Lower Thames Crossing

9.117 Applicant's Comments on IP submissions at Deadline 1 to 3

DATE: October 2023
DEADLINE: 5

Planning Inspectorate Scheme Ref: TR010032
Examination Document Ref: TR010032/EXAM/9.117

Contains Ordnance Survey data. © Crown copyright and database rights 2022. Ordnance Survey 100030649

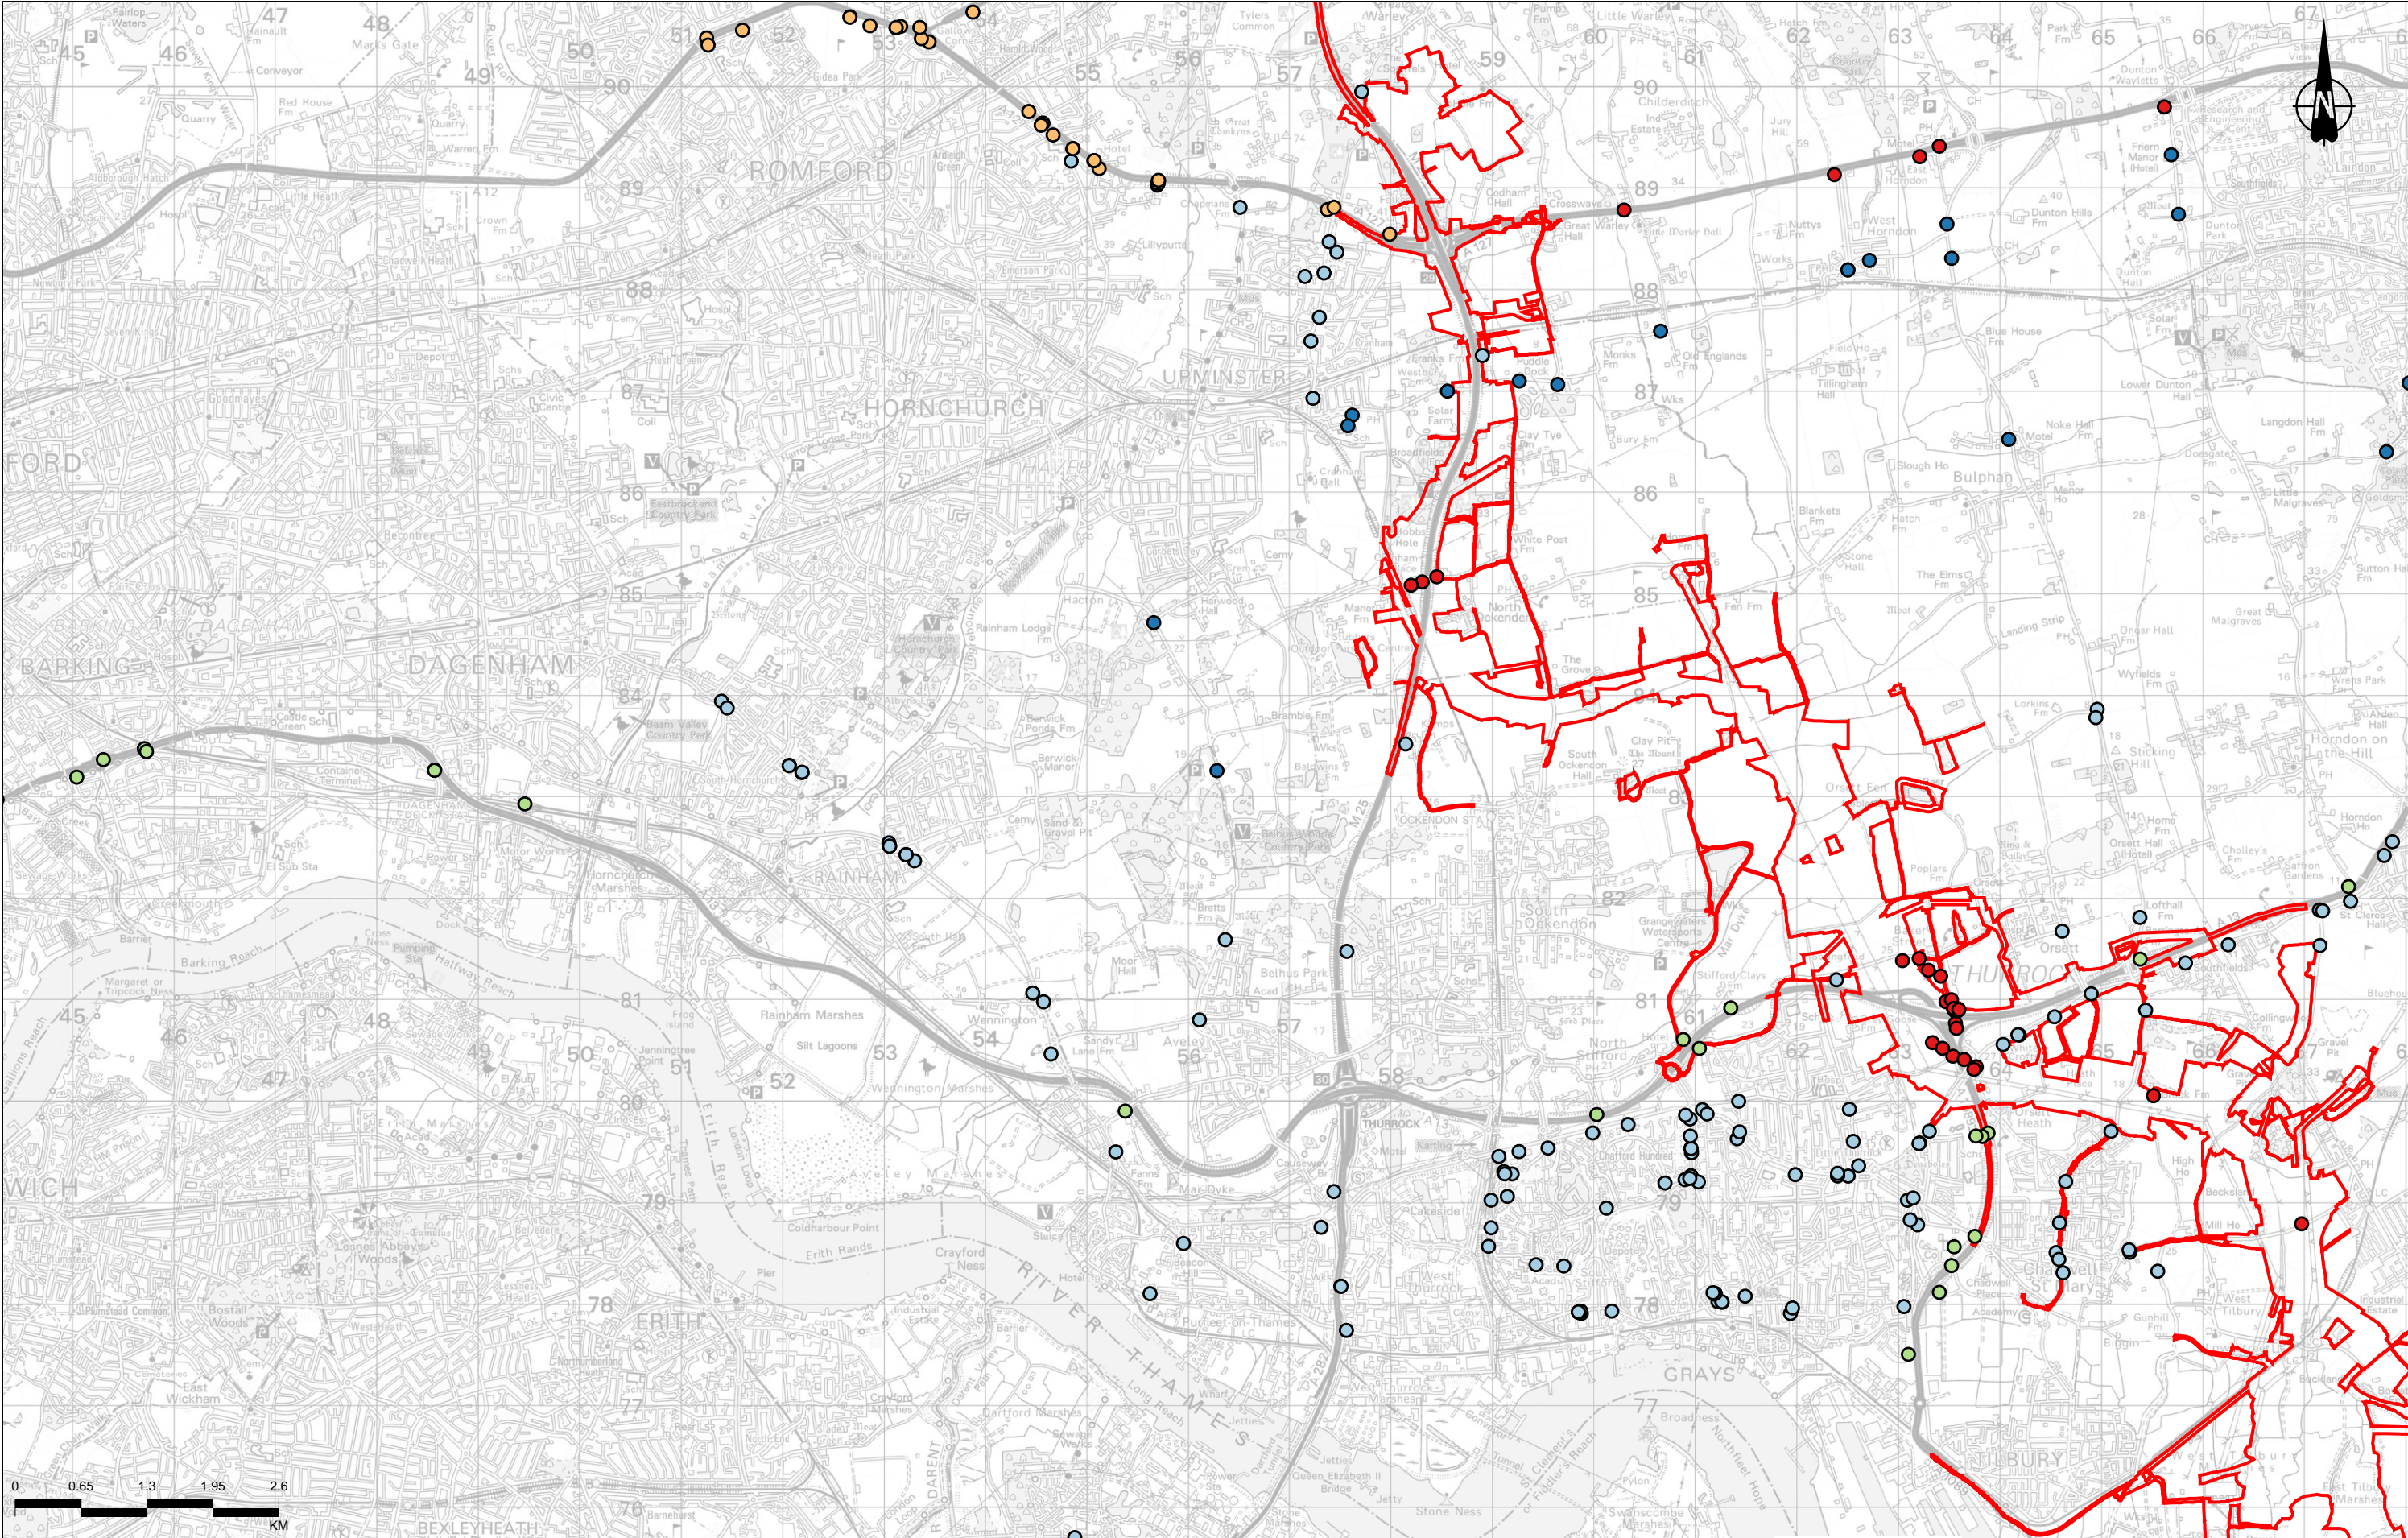
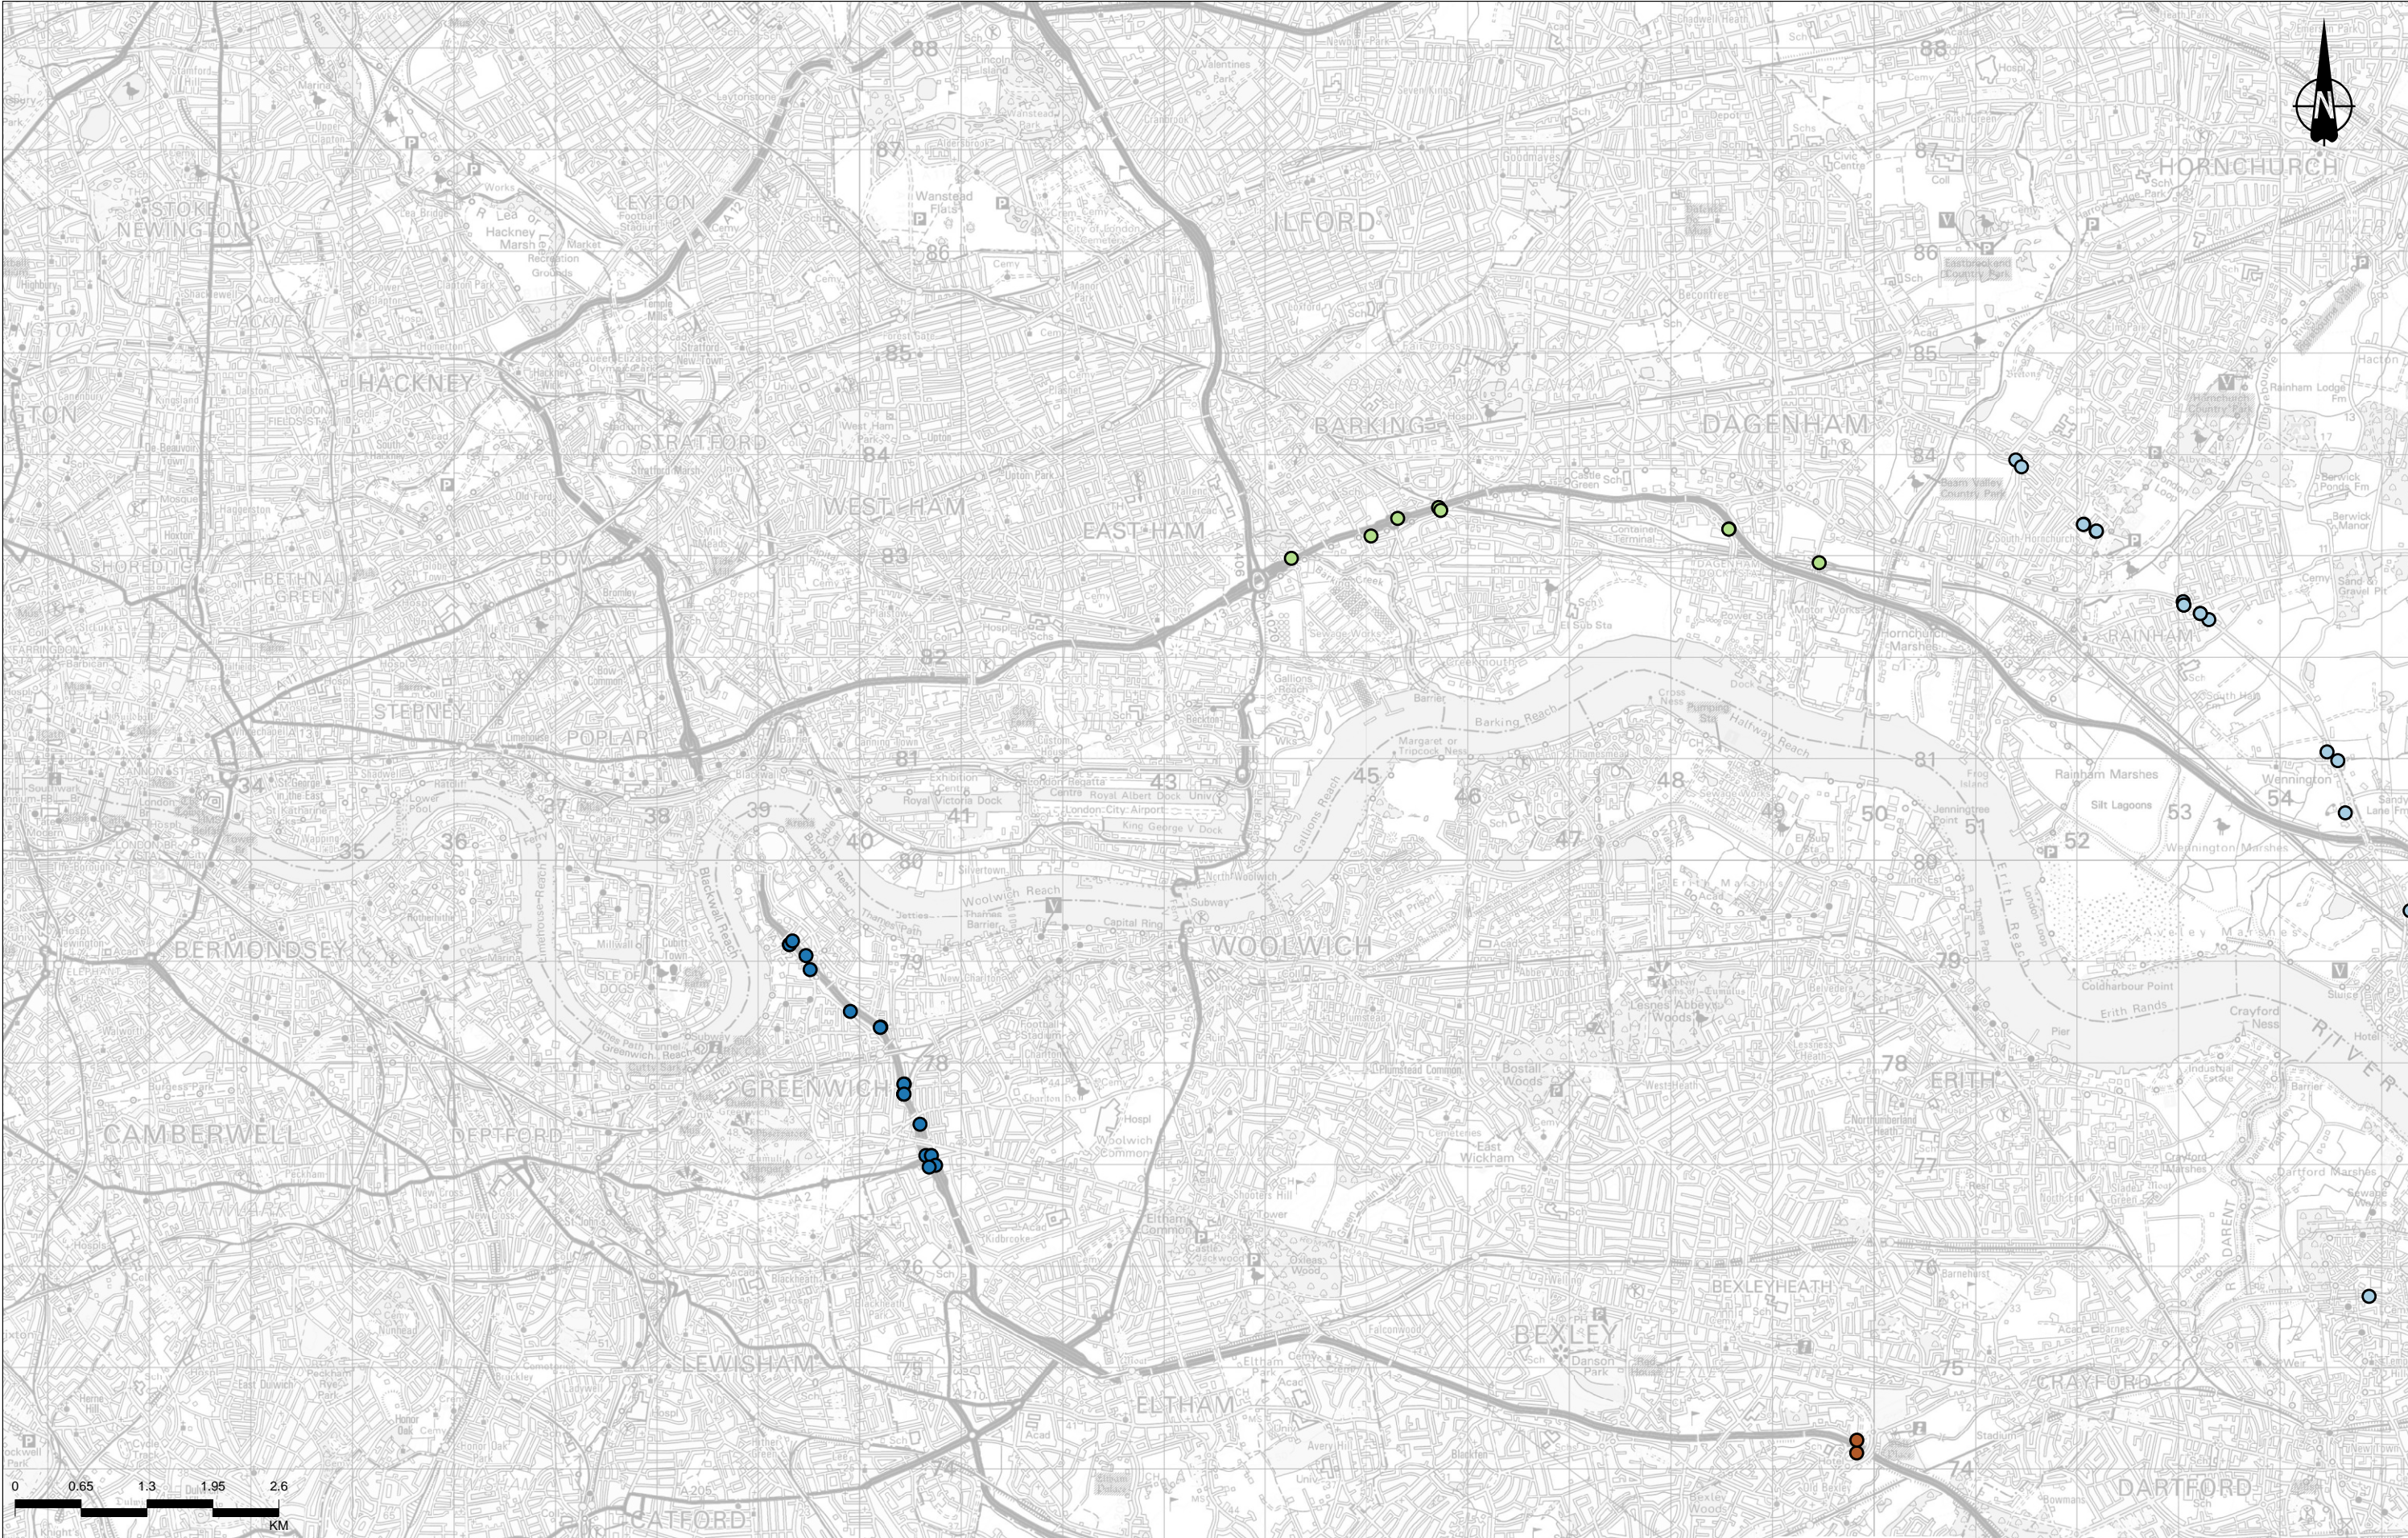
Section/Ref	Thurrock Council's comments on submissions at D1 and D2	Applicant's response
Section 18.9 – Assessment of Environmental and Health Impacts Air Quality	<p>18.9.1 The applicant's response (REP2-064) does not provide any additional information beyond that already presented in the ES Chapter 5 (APP-143) and associated appendices. This lack of engagement is disappointing and is illustrated by the response to the request within Section 10.2 of the Councils' LIR (REP1-281) for a simple figure (which the applicant will already have within their modelling) to understand the verification factors applied within the operational modelling assessment. As these factors range from 0.41 to >4 they will have a material impact upon the reported impacts at each receptor and could easily be clarified by the applicant to resolve a simple and key request.</p> <p>18.9.2 The Council therefore maintains the position that a Figure should be provided which shows where each zone has been applied and therefore which receptors are in each verification zone to better understand the reported predicted changes in air quality within the Borough (and indeed across the Study Area).</p>	<p>The Applicant has considered Thurrock Council's request in paragraphs 18.9.1 and 18.9.2 and has produced a receptors and model verification zones figure. This figure is presented in Appendix A.</p>
